SUMMARY:

**TIERRA QUE CANTA SUBDIVISION
CONCEPTUAL PLAN & VARIANCE**

JAMES W. SIEBERT AND ASSOCIATES, INC. 915 MERCER STREET • SANTA FE NEW MEXICO 87505 (305) 883-5588 FAX (305) 889-7313	TIERRA QUE CANTA		SCALE: 1"=60' DRAWN BY: JWP	DATE: JULY 2016 CHECKED BY: JWS	NORTH:
	SITE PLAN	REVISIONS: 12/17/2019	WORKED ON: 12/17/2019	FILE NAME: 1813-CONCEPT-12	SHEET: P-4

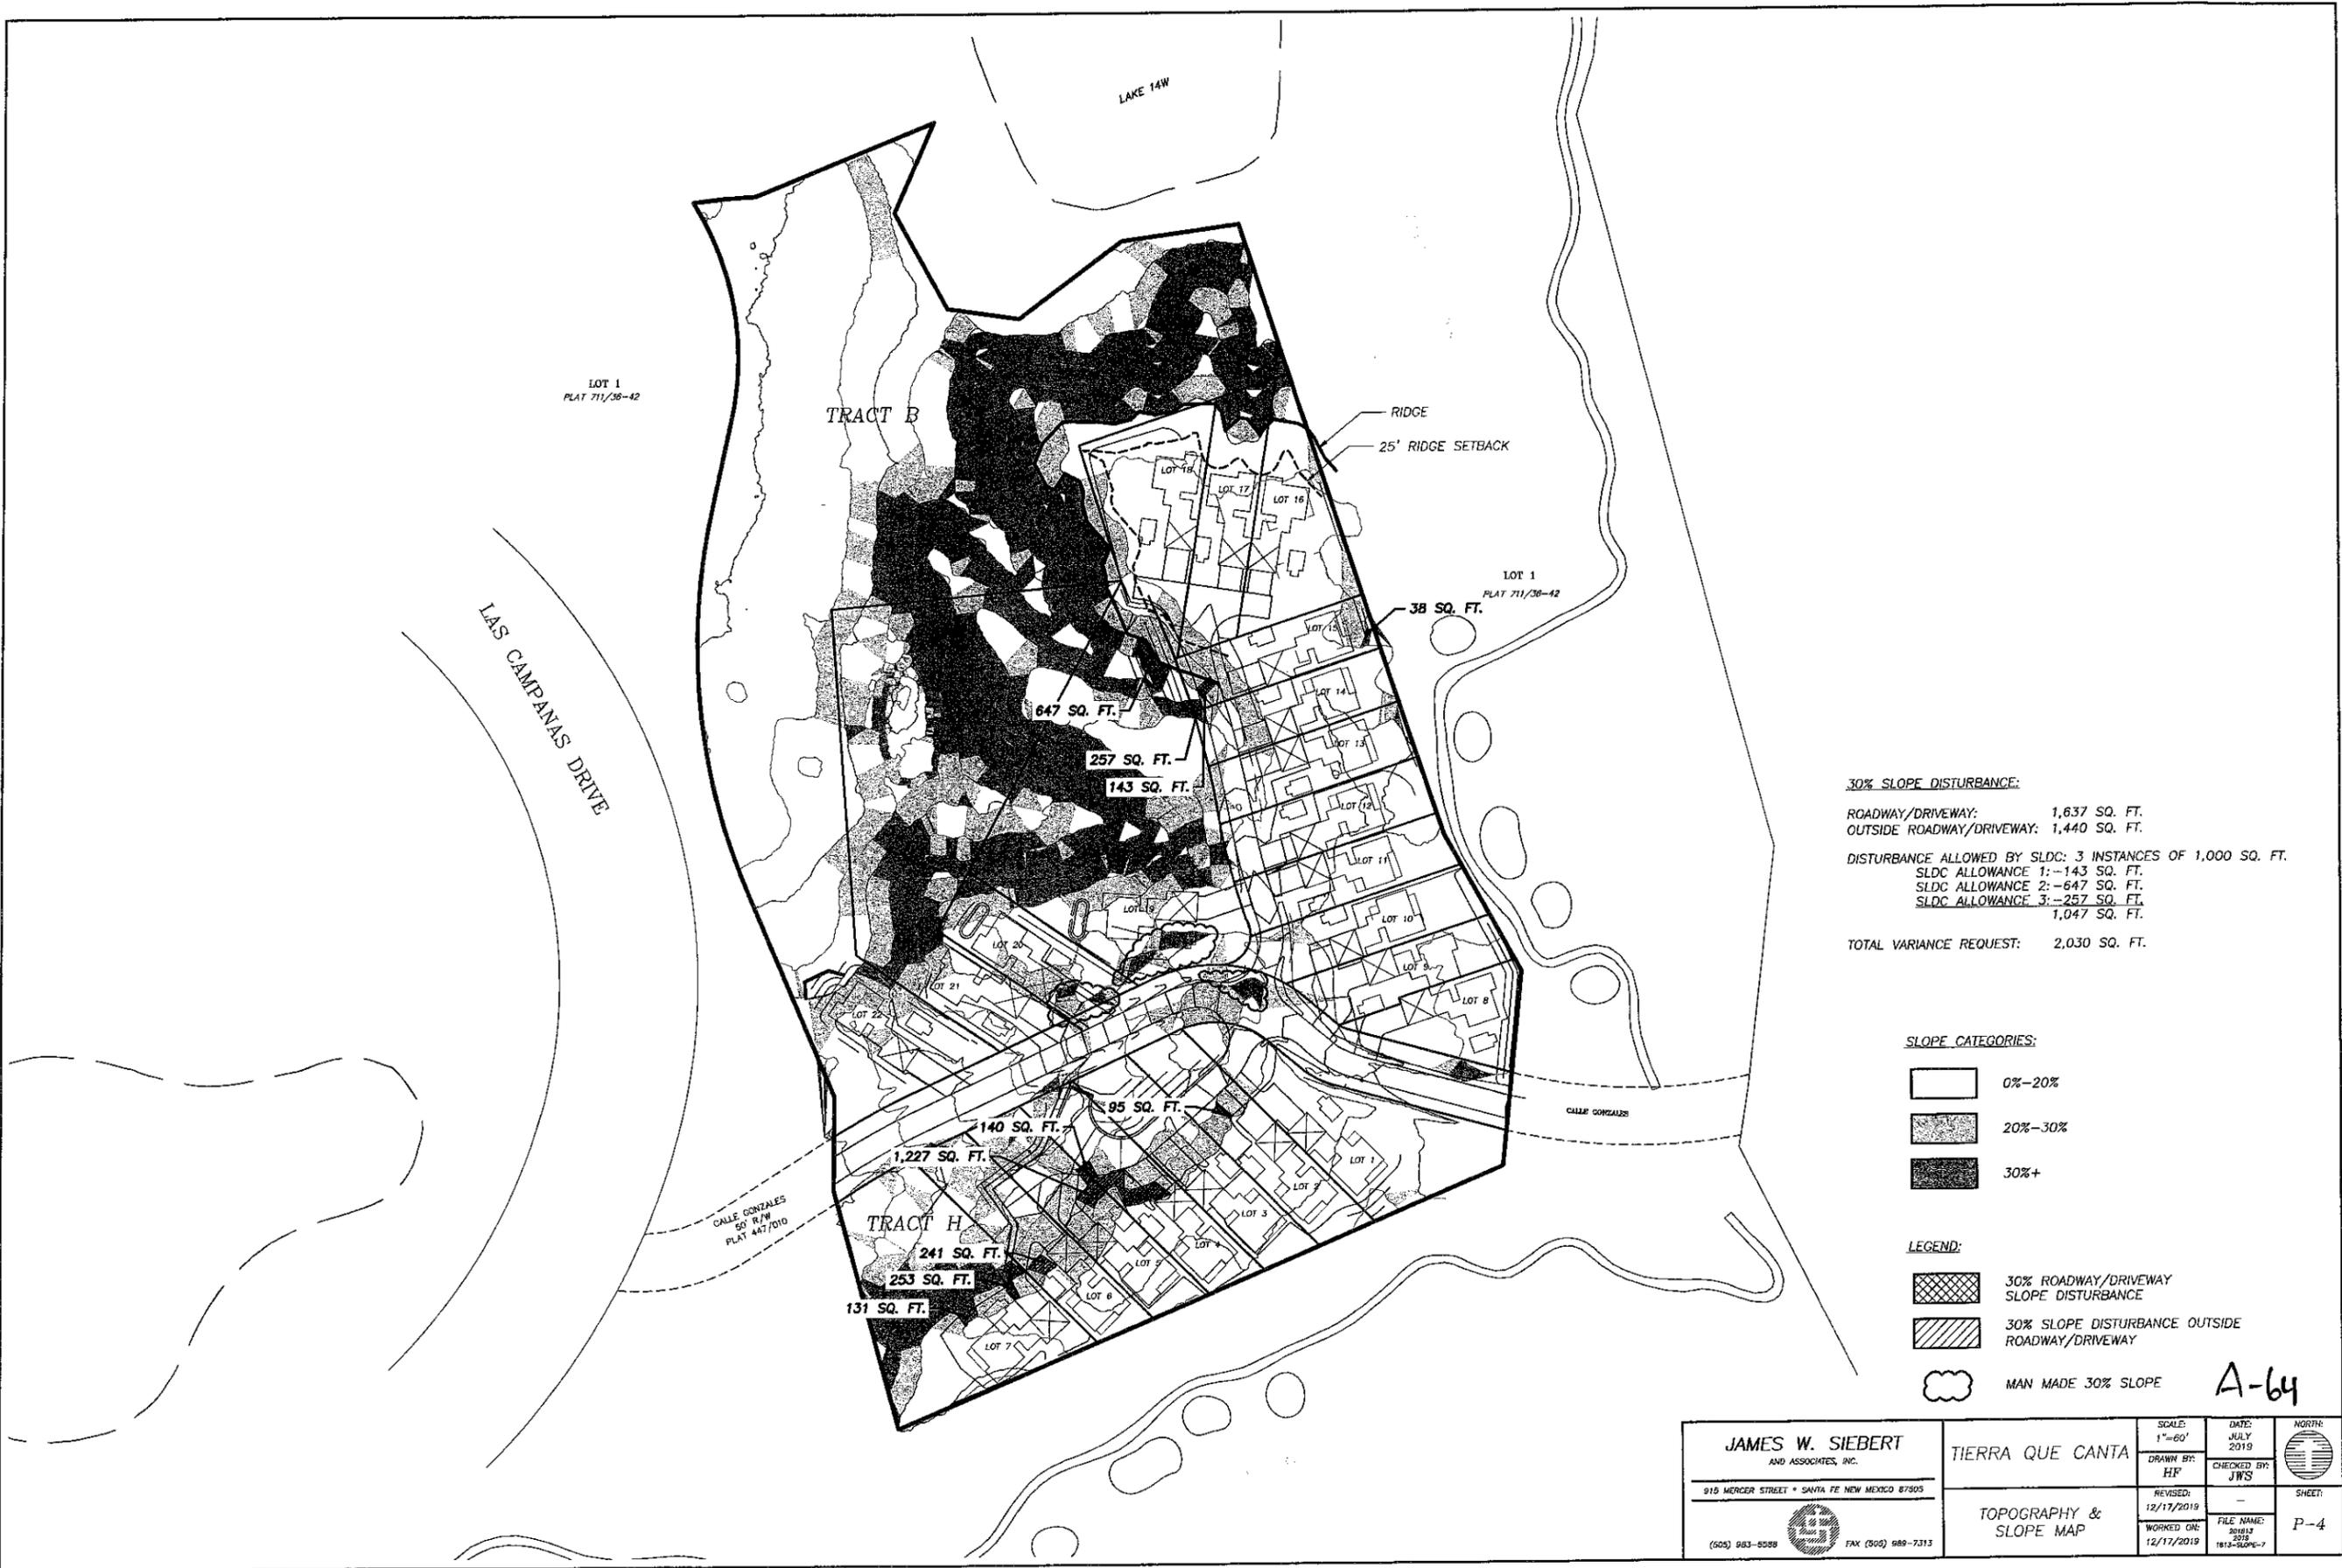
Staff Response: Staff has determined after a field inspection, due to the existing topography of the land that a road system to the development could not be installed to serve the previously approved 22 Los Santeros Master Platted lots under the current SLDC regulations without a variance. Staff finds that the Applicant will need to take proper measures to ensure that the proposed steep slope disturbances will be reclaimed, stabilized and proper drainage mitigation techniques will be used for the development. In addition, Staff recommends a Geo-Technical

Staff Response: Staff has determined that the Applicants statement does not give an arcuate representation of the overall steep terrain of the project. Per the provided Slope Analysis (Exhibit 3) a majority of Tract B is made up of slopes in excess of 30%, the terrain on Tract H is not as severe as Tract B but also poses difficulties in avoiding steep slope disturbance. Chapter 7, Section 7.17.9.2 of the Sustainable Land Development Code only allows for the disturbance of 30% slopes for driveways, roads and utilities providing the disturbance does not exceed 1,000 square feet and no more than three occurrences. Tract B will be disturbing 1,928 square feet of 30% (+) slopes in five (5) isolated occurrences, which is not allowed by the SLDC. Tract H will be disturbing 2,087 square feet of 30% (+) slopes in six (6) isolated occurrences which is not allowed by the SLDC. Staff recognizes that the total square footage of steep slopes being disturbed compared to overall land mass of 12.23 acres (±) is minimal in comparison, therefore, Staff has determined that the requested variance is within the spirit of the SLDC. The property poses difficult building locations due to the topography and soft soils of the land. A majority of the lots and homes built within Tierra Que Canta will be created on slopes less than 15%. Lots located on steeper terrain and close to drainages will be subject to meeting applicable Terrain Management and Design Standard setbacks and regulations of the SLDC. In addition, the Applicant has incorporated the existing terrain into the designing of the roads and housed-pads within the development, thus making an attempt in preserving the natural beauty of the land.

JAMES W. SIEBERT AND ASSOCIATES, INC. 915 MERCER STREET • SANTA FE, NEW MEXICO 87505 (505) 983-5588 FAX (505) 989-7313	TIERRA QUE CANTA		SCALE: 1"=60' DATE: JULY 2019	NORTH 
	DRAWN BY: HP	CHECKED BY: JWS	SHEET: P-4	FILE NAME: 20180722 1883-CONCEPT-12
12/17/2019	12/17/2019	SITE PLAN

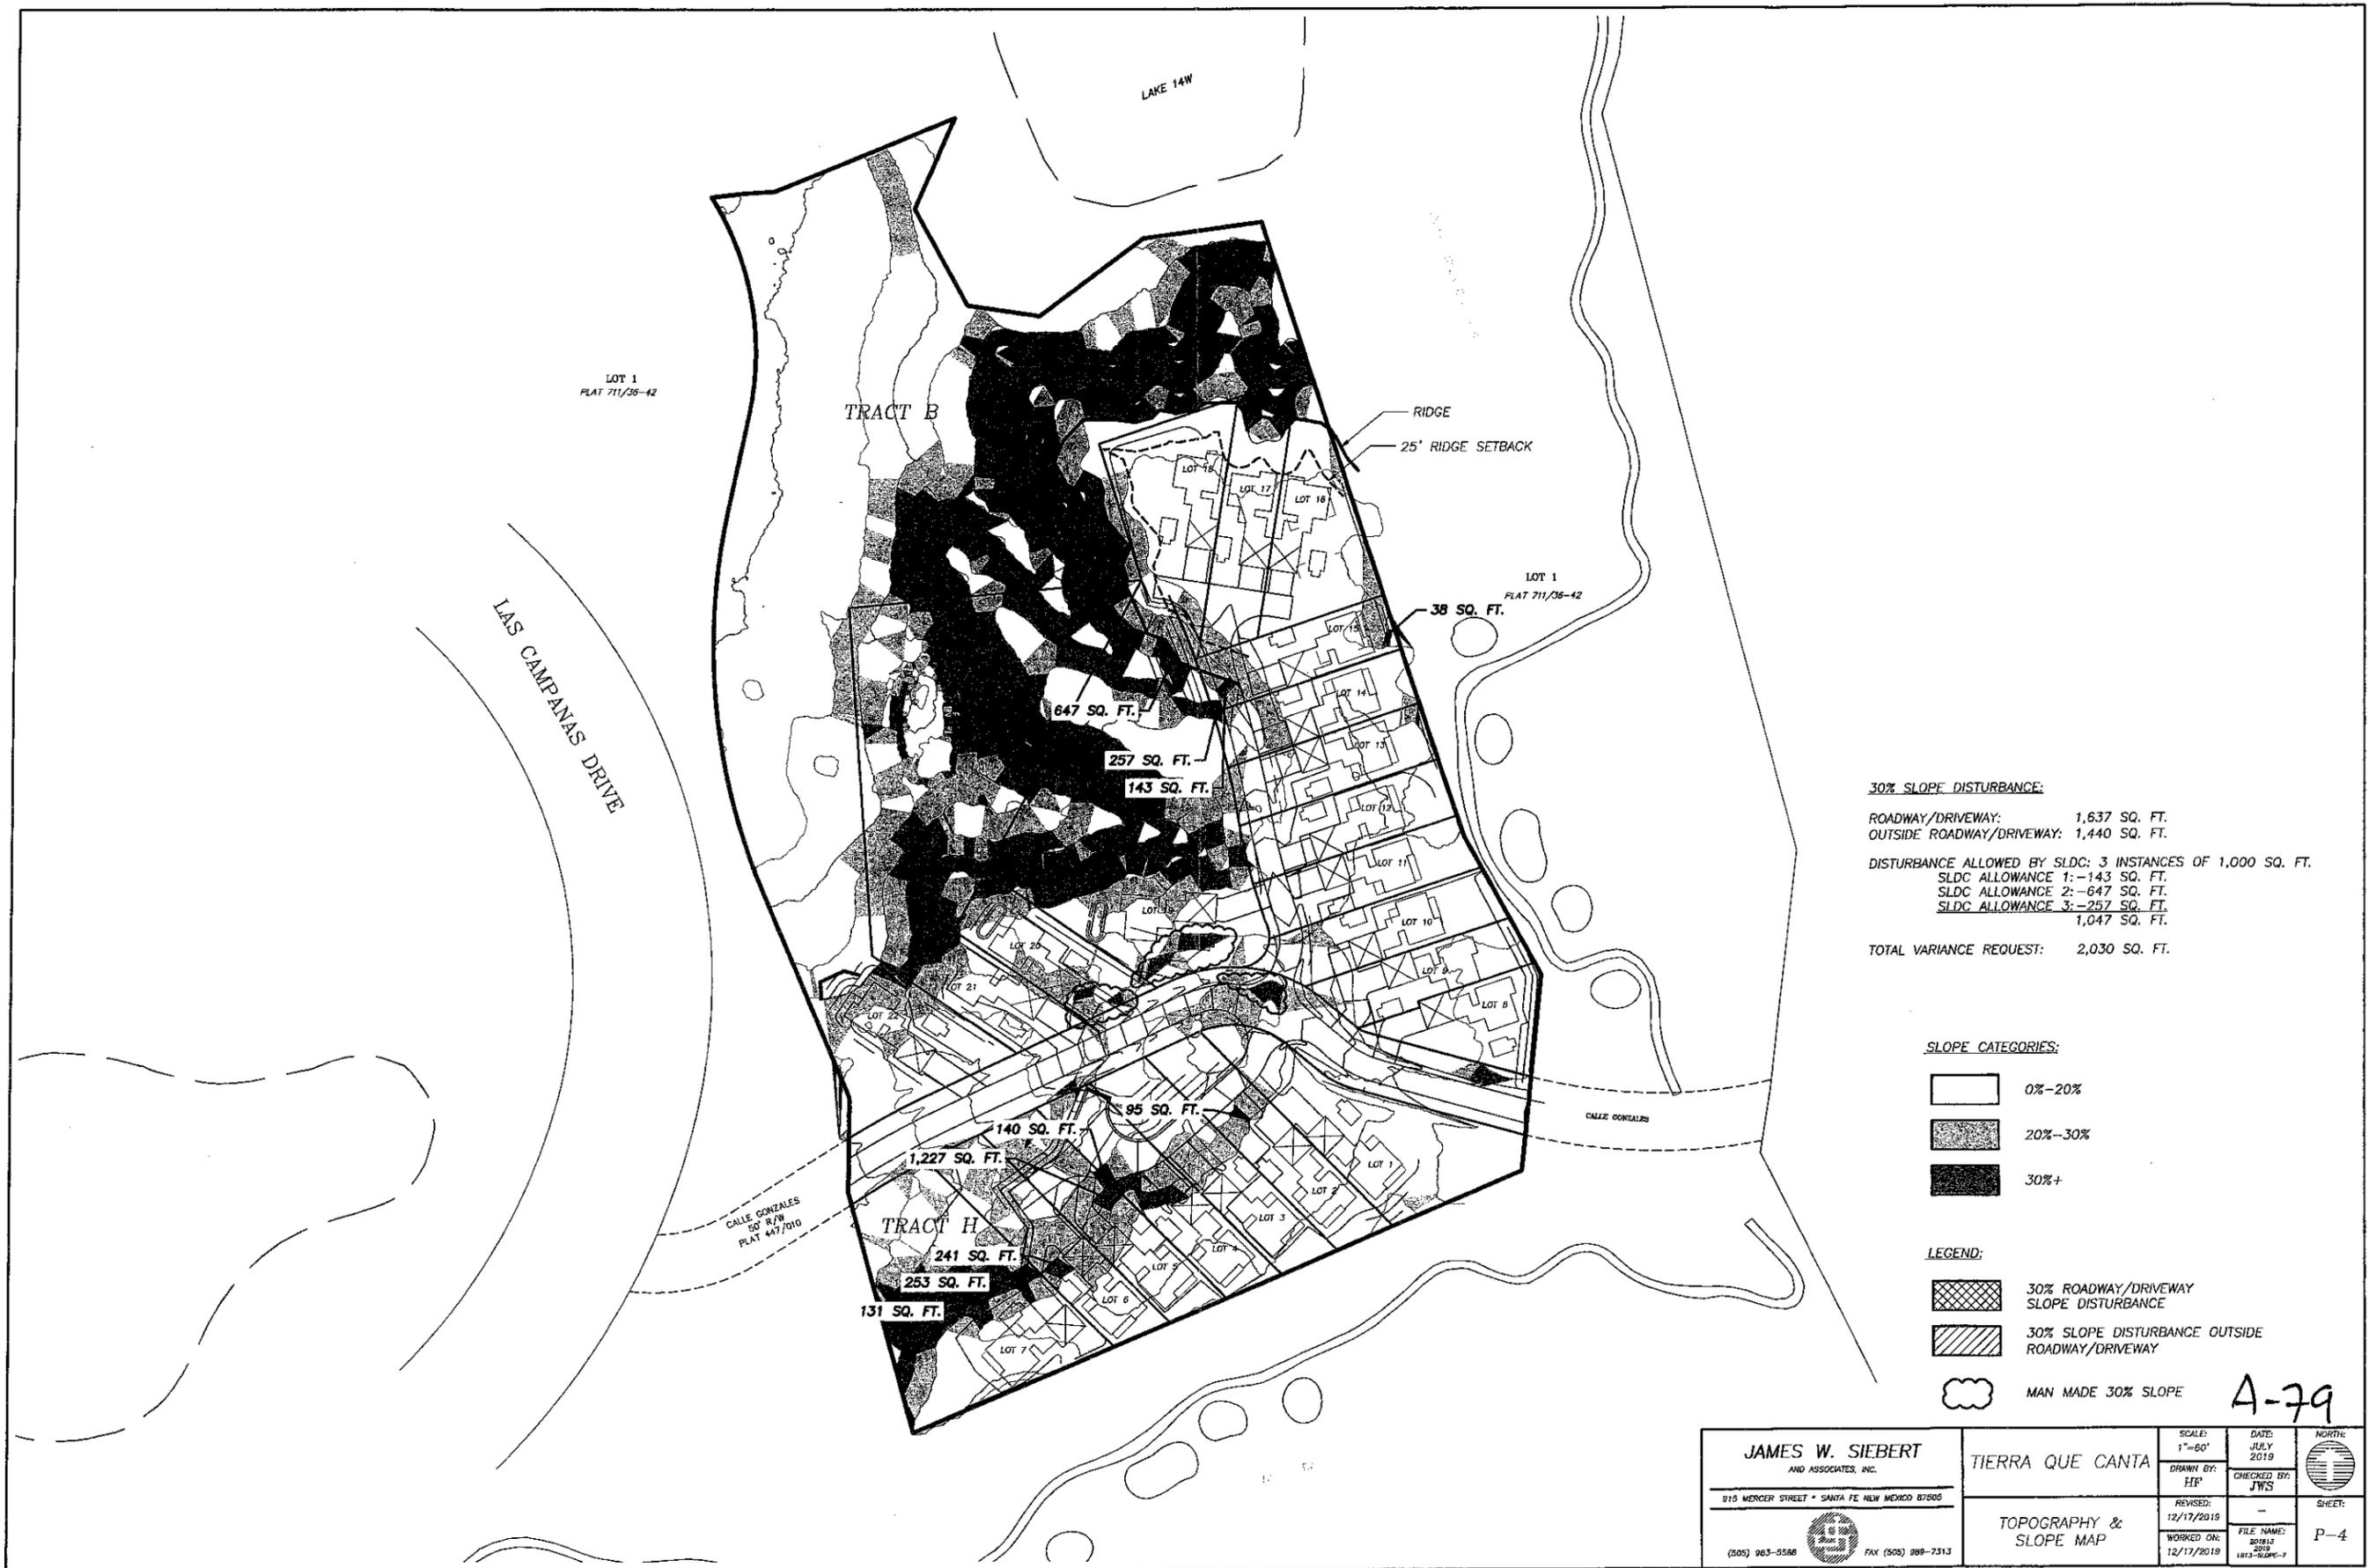
Staff Response: Staff has met with the Applicant and has discussed the current design as well as alternative designs that may be used to achieve greater intersection separations for the driveways accessing directly off the proposed 4-way stop intersection (Exhibit 10). Staff understands that the Applicant cannot meet the required 100-foot separation from any of the return radii of the driveways in the development due to the tight building envelopes of the site. Staff has let with the Applicant know that the proposal may be eligible for a deviation by the Administrator per Ordinance 2017-7, Section 7.11.12.4. If the driveways located near the return radiuses of the 4-way stop are greater than 25 feet, the Administrator would be amenable to granting a deviation. Staff has recommended to the Applicant for the driveway located on Lot 1 to align with the driveway on Lot 8, as well as for the driveway located on Lot 2 to run along the south western most part of the property. By relocating / teeing up the driveway on Lot 1 & Lot 8 as well as shifting the Driveway on Lot 2 all driveways in the development would meet a minimum 25’ feet setback from radiuses of the proposed 4-way intersection. The Applicant has rejected the County’s recommendation and therefore request a variance. Staff recommends conditional approval of the Applicant variance request and request that all driveways within Tierra Que Canta be a minimum 25’ feet from the return radius of the proposed 4-way intersection. The aim of this request is to increase overall safety and efficiency of the proposed 4-way intersection.

- a. All driveways within Tierra Que Canta to be a minimum 25' feet from the return radius of the proposed 4-way intersection.
- b. Applicant must submit a reconfigured road design showing all driveways with the development 25' feet from the return radius of the proposed 4-way intersection, prior to this request being heard by the Planning Commission.
- c. Construction gate located at the end of Calle Gonzales must be removed upon completion infrastructure and road construction.
- d. Limits of grading shall be addressed with Preliminary & Final Plat submittal.
